SUBJECT: COMANCHE PEAK STEAM ELECTRIC STATION (CPSES)-UNIT 1
DOCKET NO. 50-445
INSERVICE INSPECTION PROGRAM RELIEF REQUESTS

This letter requests relief from the inservice examination requirements. The requirements for the examinations are found in Section XI of the ASME Boiler and Pressure Vessel Code. The relief requests and related sketches are found in the attachments to this letter.

TBX -1-1300 | REV.1 | 7-20-90

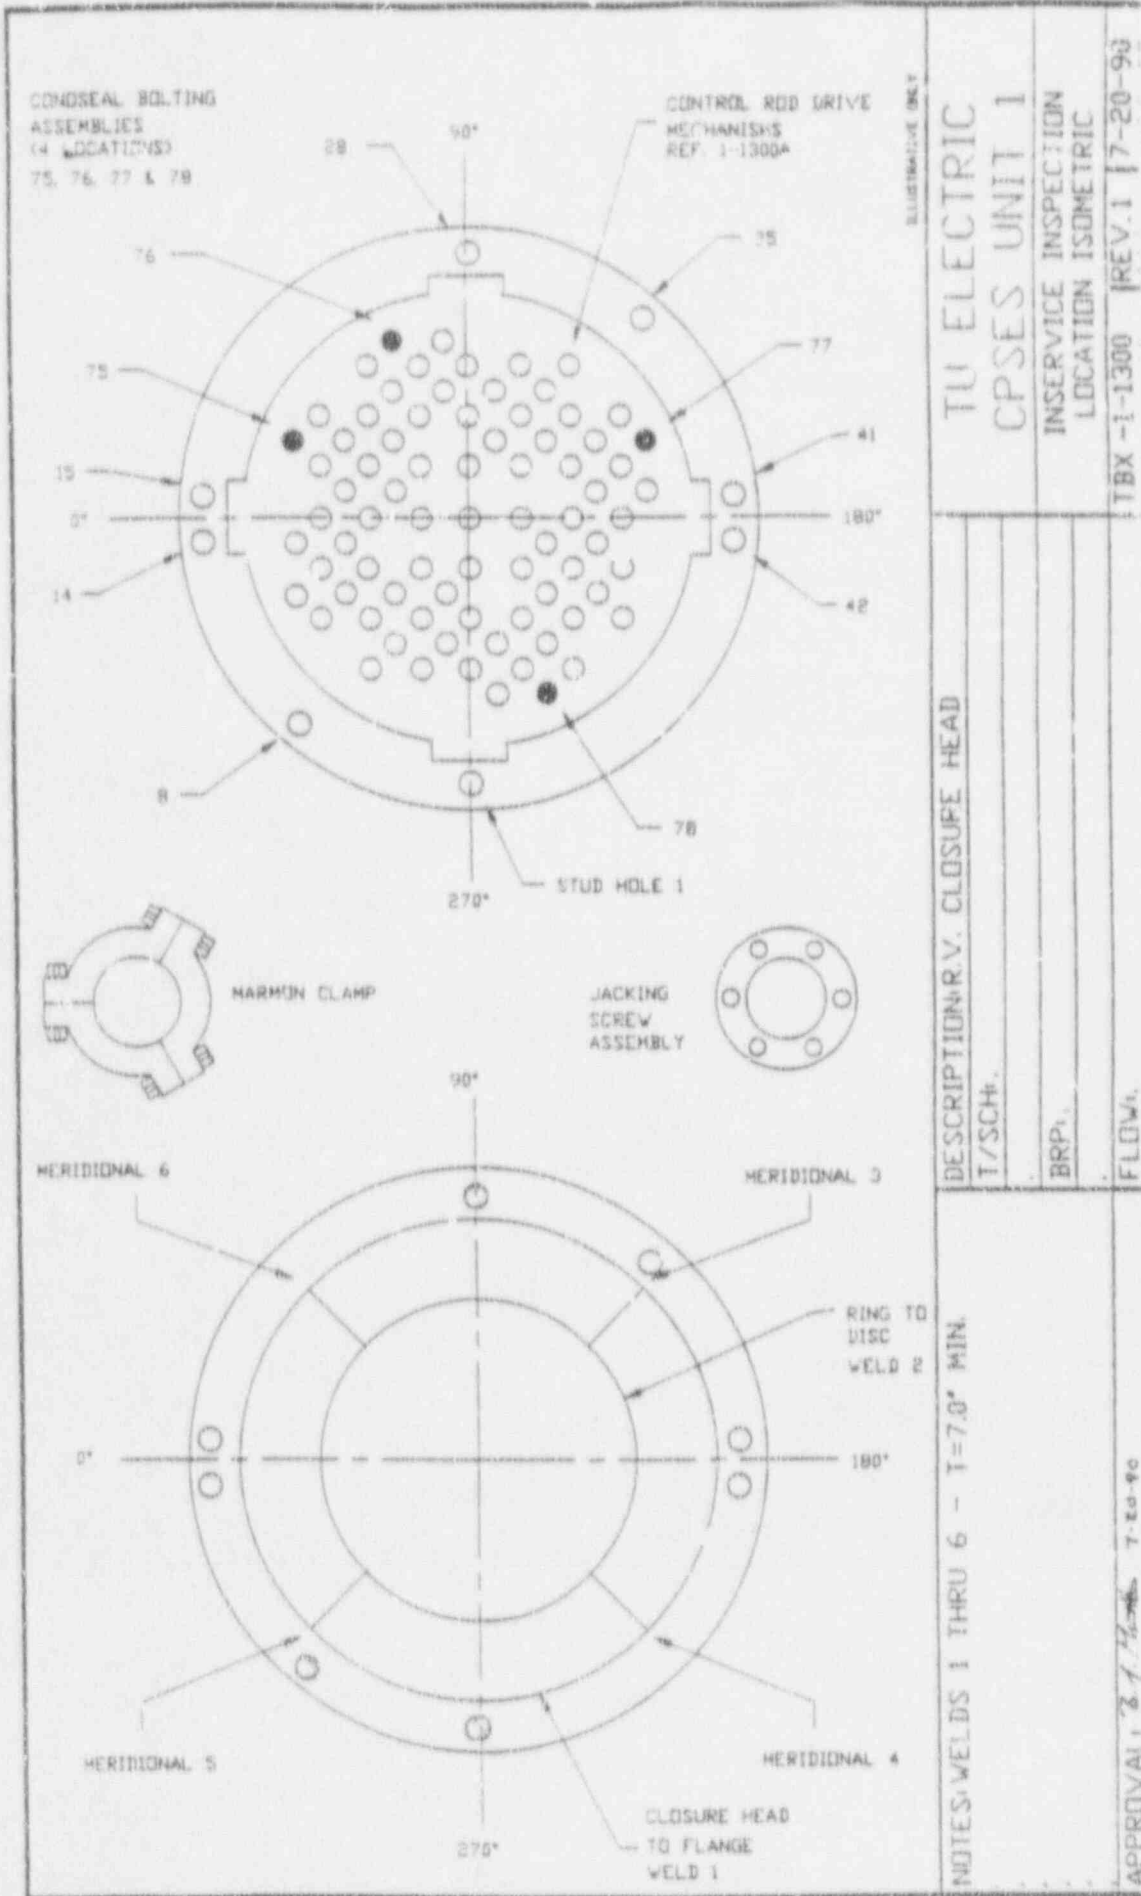
Items for Which Relief is Requested: RV closure head to flange weld (TBX-1-1300-1) and RV closure head ring to disc weld (TBX-1-1300-2). See attached drawing.

Basis for Relief: 1/3 of welds TBX-1-1300-1 and TBX-1-1300-2 were ultrasonically examined to the maximum extent possible, however, a portion of each was unable to be examined due to limitations encountered from the flange, shroud and a lifting lug. Required surface exam was performed and resulted in no indications. See attached Limitation to Examination sheet.

PLANT COMANCHE PEAK UNIT NO. 1 SKETCH TBR-1-1300 REV. 1
 SYST/COMP R.V. CLOSURE / 680 PROCEDURE TX-ESI-210 REV. 5.1
 EXAMINER [Signature] DATE 10-28-91
 LEVEL II

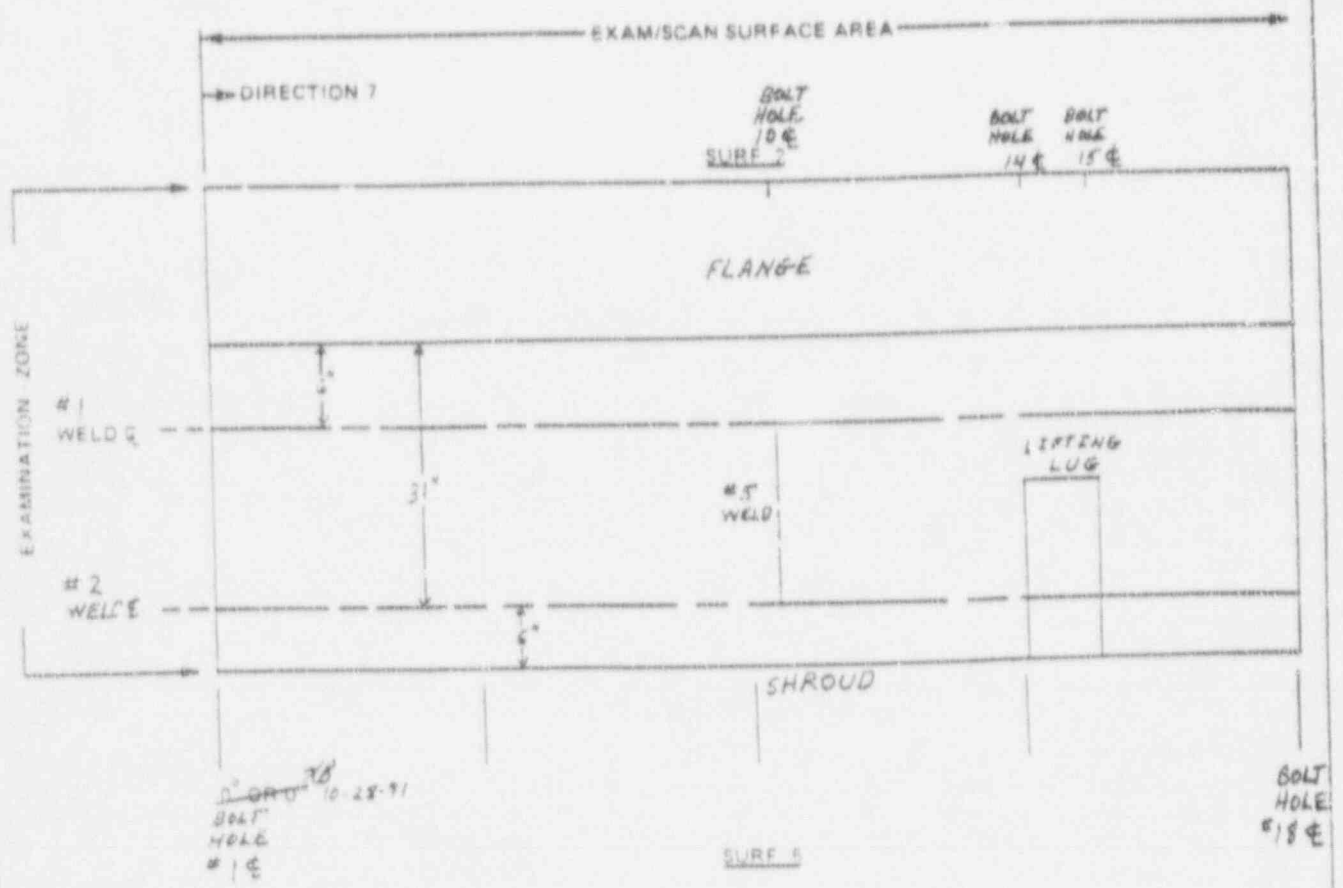
NOTE:
 8% of weld #1 not examined using 45° angle beam
 13% of weld #2 not examined using 45° angle beam
 12% of weld #1 not examined using 60° angle beam
 17% of weld #2 not examined using 60° angle beam

PLANT COMANCHE PEAK UNIT No. 2 SKETCH TBX-1-4103 REV 1
 SYST/COMP SAFETY SECTION PROCEDURE TX-TSI-207 REV. Q FC 1, 2 & 3
 EXAMINER Juan R. Delbano, Robert L. Cant DATE 10-22-91
 LEVEL II

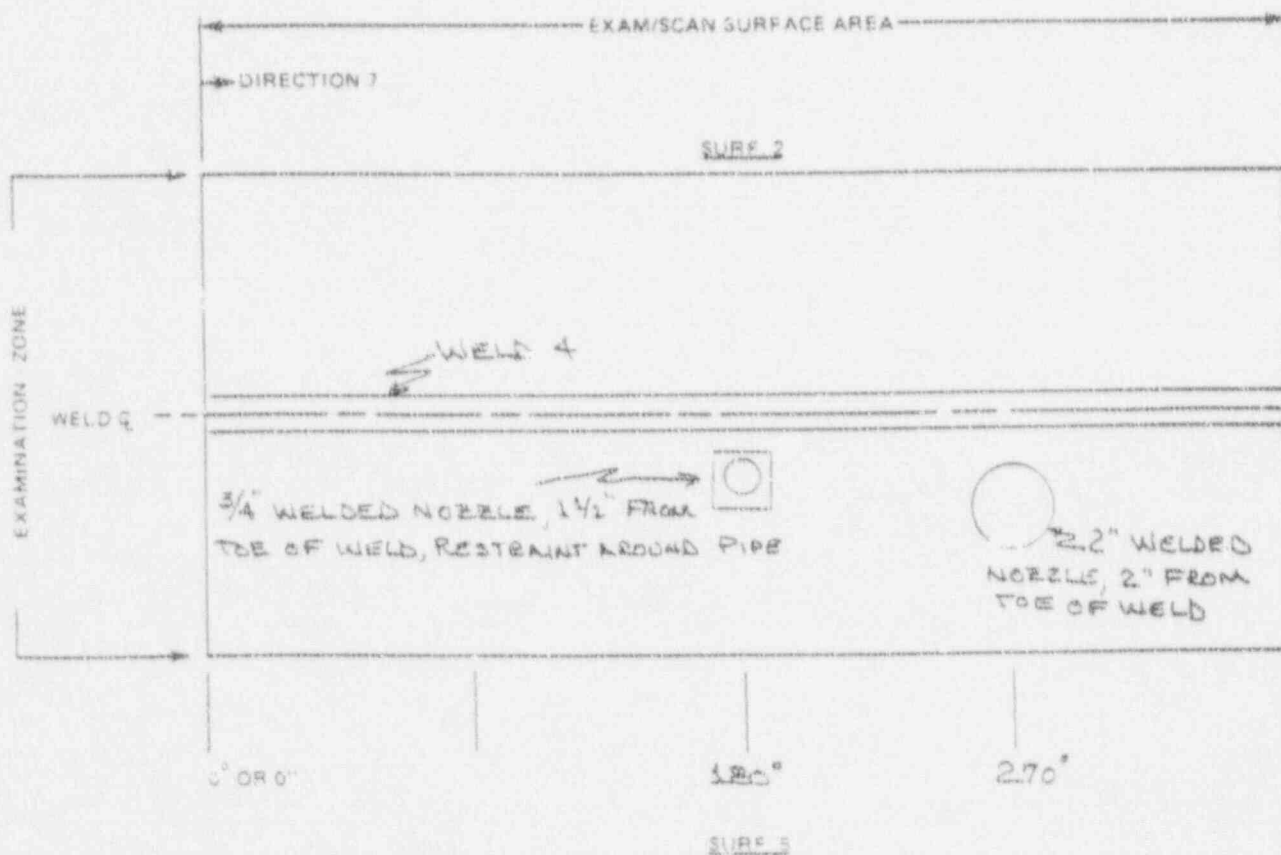
Basis for Relief: Weld TBX-1-4103-4 was ultrasonically examined to the maximum extent possible, however, a portion of the weld was unable to be examined due to limitations encountered from pipe nozzles and a component support. The required surface examination was performed and resulted in no indication. See attached Limitation to Examination sheet.

2 WELDED NOZZLES AND BOX RESTRAINT LIMITS 8" OF SCAN, 3 1/2" OF 7:8 SCAN. 100% OF 2 SCAN ACCOMPLISHED BY COMBINATION OF 45°-60° SHEAR AND 70° LONGITUDINAL. APPROX 10% OF EXAMINATION VOLUME NOT EXAMINED.

PLANT COMANCHE PEAK UNIT No. 1 SKETCH TRX-1-4503 Rev 1
SYST COMP PRESSURIZER SPRAY PROCEDURE TX-ESI-207, REV. 0, FC1213
EXAMINER James R. Sullivan DATE 10-31-91
LEVEL II

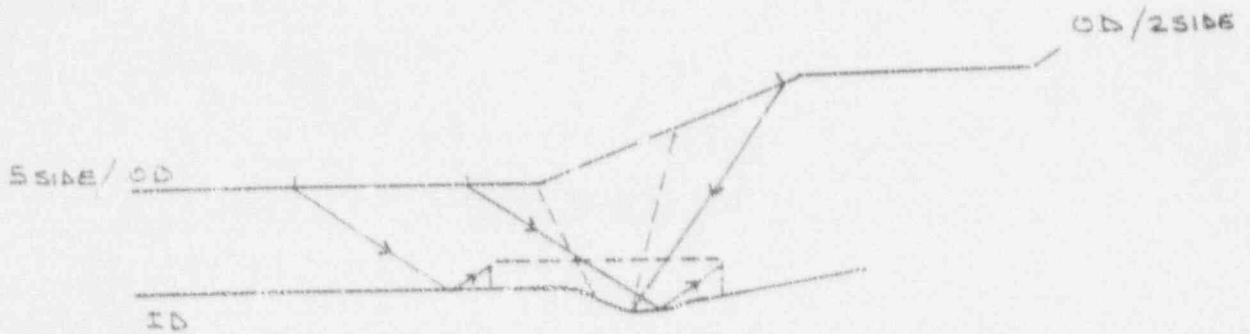
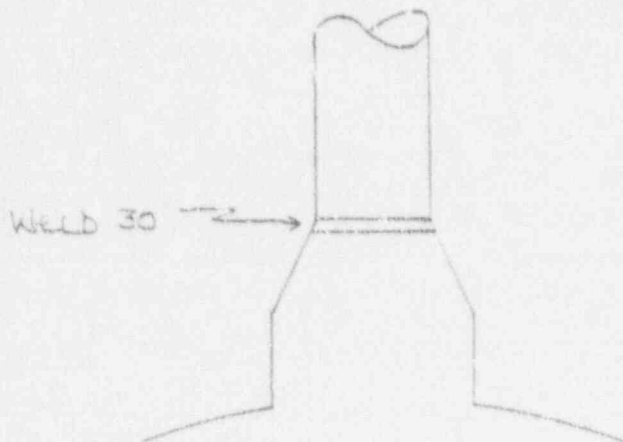
Basis for Relief: Weld TBX-1-4503-30 was ultrasonically examined to the maximum extent possible, however, a portion of the weld was unable to be examined due to limitations encountered from the reducing nozzle. The required surface examination was performed and resulted in no indications. See attached Limitation to Examination sheet.

WELD CONFIGURATION (PIPE TO
REDUCING NOZZLE) RESTRICTS ALL
SCANS. APPROX. 15% OF EXAMINATION
VOLUME NOT EXAMINED.

PLANT COMANCHE PEAK UNIT No 1 SKETCH TBX-2-1120 REV 1
SYST/COMP RESIDUAL HEAT EXCHANGER PROCEDURE IX-ISI 209 REV 0 FC 1
EXAMINER JAMES R. Dellbana DATE 10-2-91
LEVEL II

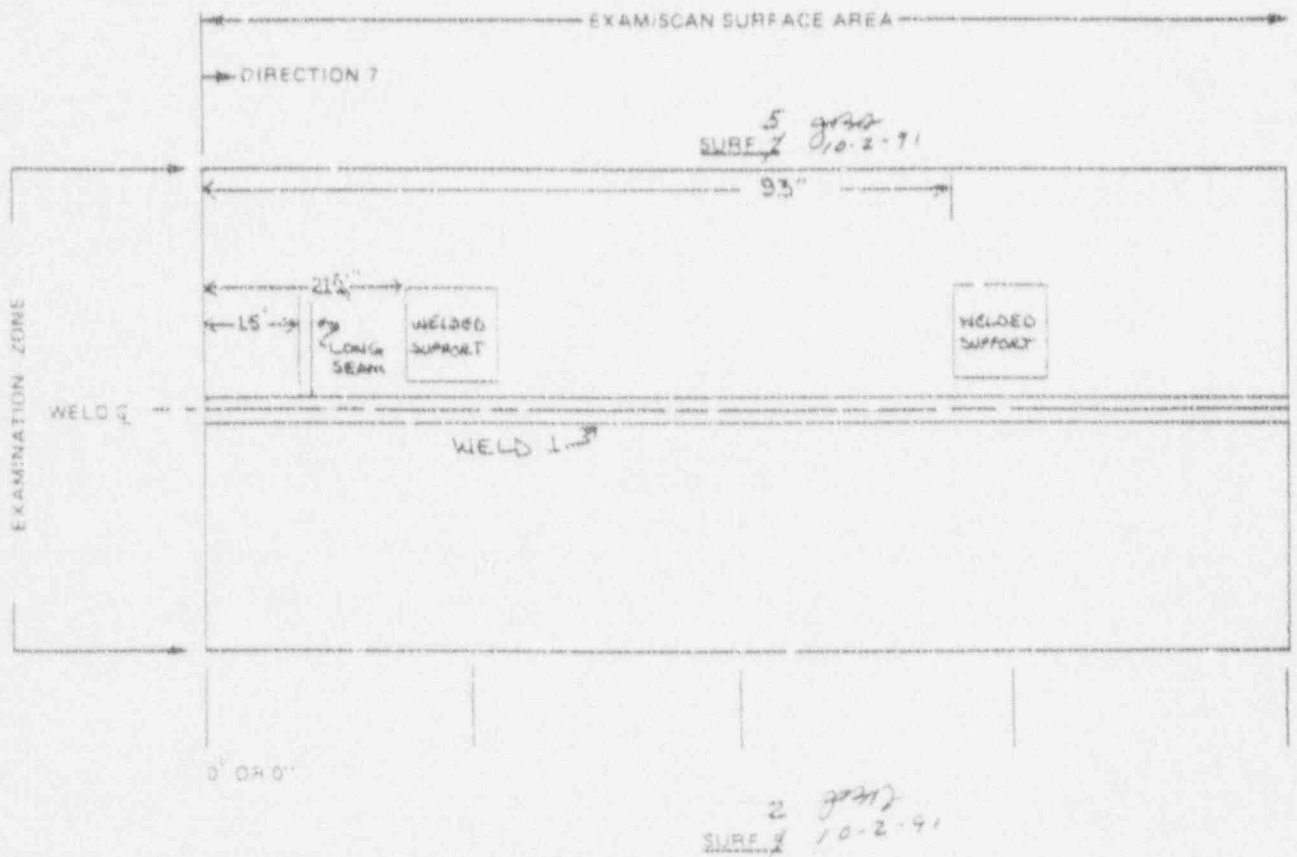
Basis for Relief: Welds TBX-2-1120-1-1 and TBX-2-1120-1-2 were ultrasonically examined to the maximum extent possible, however, a portion of each weld was unable to be examined due to limitations encountered. See attached Limitation to Examination sheets.

2 WELDED SUPPORTS RESTRICT 2, 7 & 8 SCANS.
APPROX. 18% OF EXAMINATION VOLUME NOT EXAMINED

PLANT COMANCHE PEAK UNIT NO. 1 SKETCH TBX-2-1120 REV. 1
SYSTEM COMP. RESIDUAL HEAT EXCHANGER PROCEDURE IX-151-209 REV. 0 F.C. 1
EXAMINER [Signature] DATE 10-2-91
LEVEL II

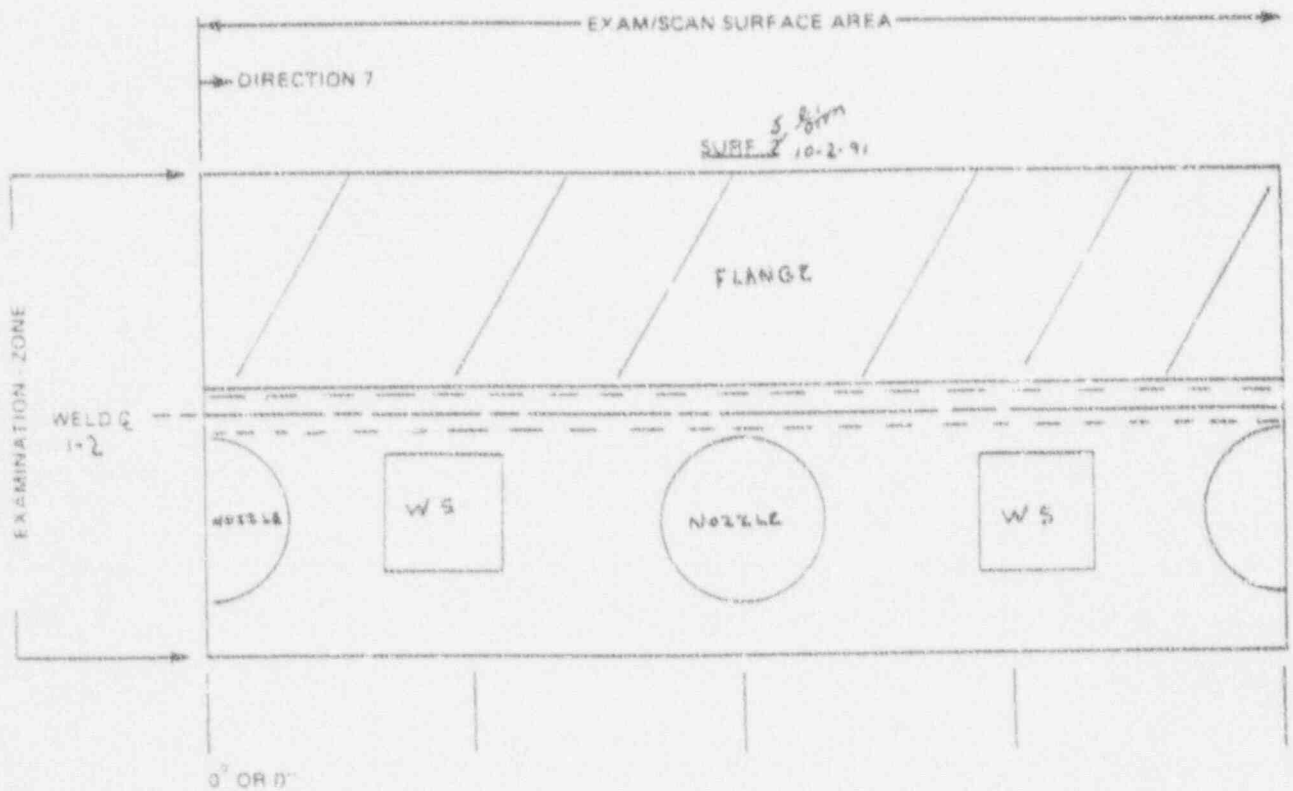
WELDED SUPPORTS + NOZZLES LIMITS 2, 7/8 SCANS.

FLANGE RESTRICTS ALL SCANS.

42% NOT EXAMINED

PLANT COMANCHE PEAK UNIT NO. 1 SKETCH JBY-2-2570, REV. 1
SYST. COMP. CHARGING PUMP #2 DISCHARGE PROCEDURE TX-ISE-207 Rev. 0, FC 178
EXAMINER James R. Dellano DATE 9-30-91
LEVEL II

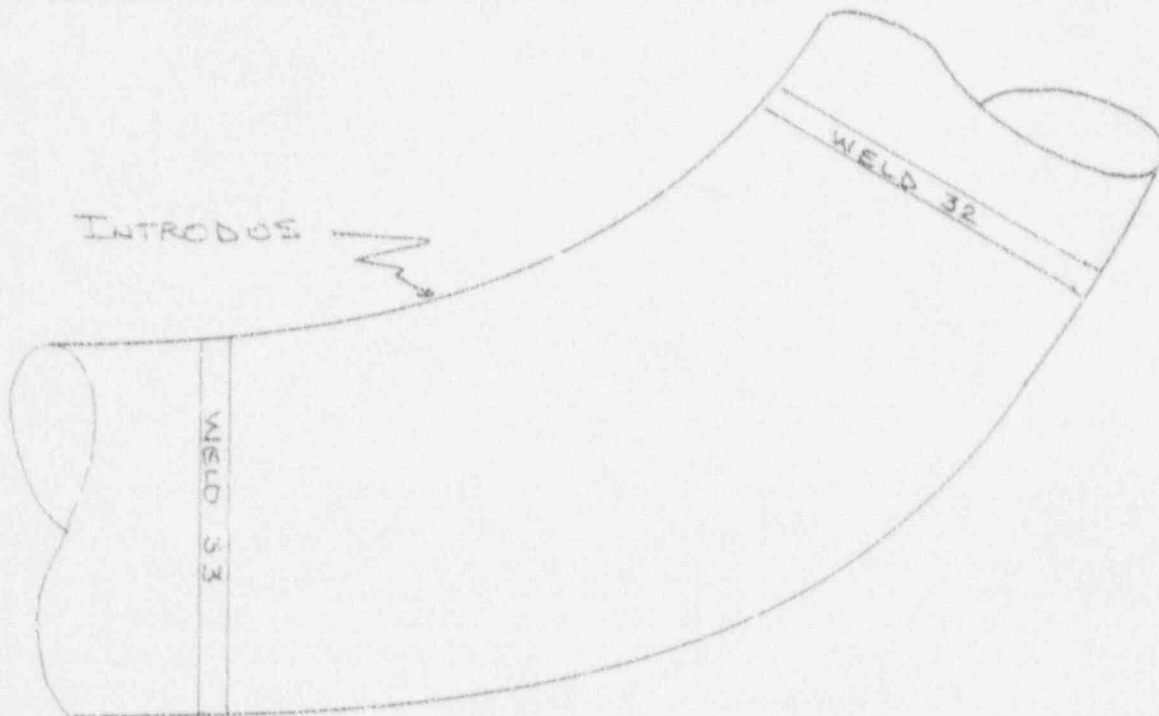
Basis for Relief: Welds TBX-2-2570-32 and TBX-2-2570-33 were ultrasonically
examined to the maximum extent possible; however, a
portion of each weld was unable to be examined due to
limitations of the elbow intrados. Required surface
examinations were performed with no resulting
indications. See attached Limitation to Examination
sheet.

INTRODOS OF 45° ELBOW RESTRICTS 4" OF
2 7/8 SCANS FOR WELD 32 AND 4" OF 5 7/8
SCANS FOR WELD 33 14% OF EXAMINATION
VOLUME FOR WELDS 32 AND 33 NOT EXAMINED

PLANT COMANCHE PEAK UNIT No. 1 SKETCH TBX-2-2536 REV. 2
SYST COMP CONTAINMENT SLAY PROCEDURE TX-ISE-11 REV. 2
EXAMINER Charles W. Kiehl & John J. Kelly DATE 10-12-91
LEVEL II

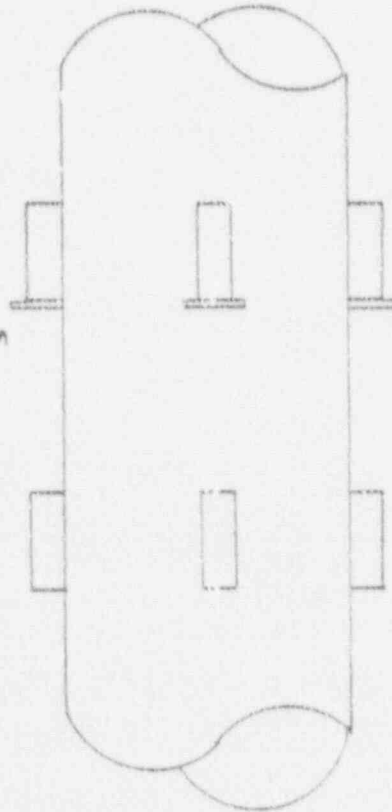
Basis for Relief: Integrally welded attachments TBX-2-2536-H2 and
TBX-2-2538-H17 were surface examined to the maximum
extent possible; however, a portion of each weld was
unable to be examined due to limitations associated with
welded spacers on the bottom surface of the top lugs.
See attached Limitation to Examination sheet.

WELDED SPACERS ON BOTTOM SURFACE OF TOP LUGS
LIMITS 1/2" OF EVAP VOLUME ON LUG (4) TOTAL

PLANT COHANOCHE PEAK UNIT NO. 1 SKETCH TBX-2-2538 REV. 2
SYST COMP CONTAINMENT SPRAY PROCEDURE TK-151-11 REV. 2
EXAMINER [Signature] LEVEL II DATE 10-8-91

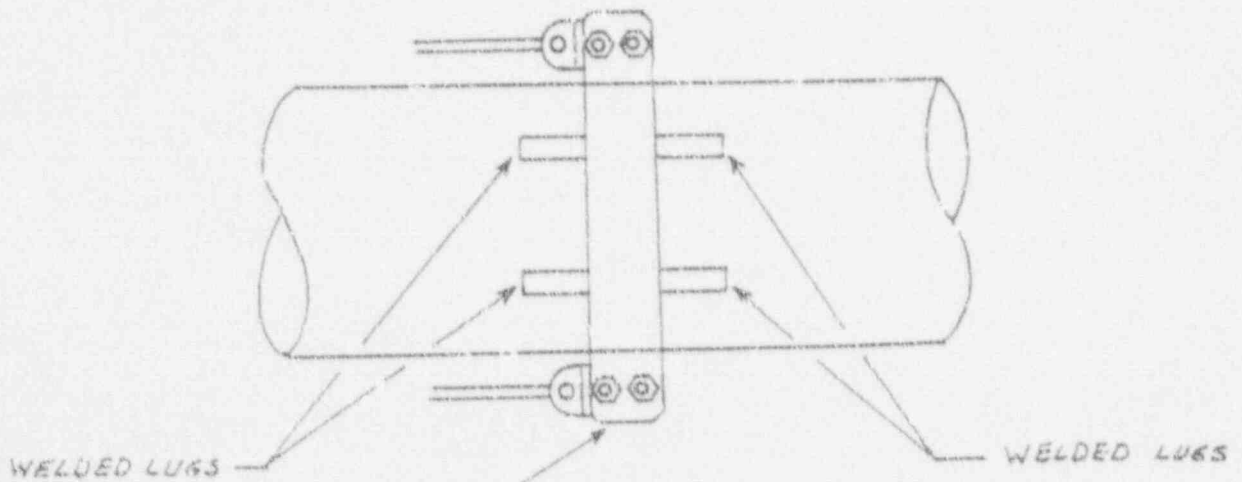
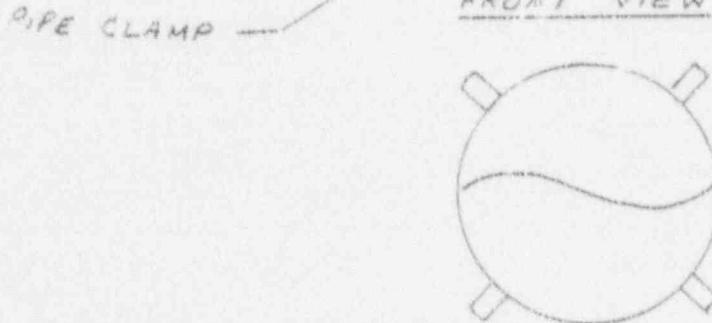
PIPE CLAMP RESTRICTS P.T. EXAMINATION ON ALL 8
WELDED LUGS 1/2" ON SIDES ADJACENT TO CLAMP
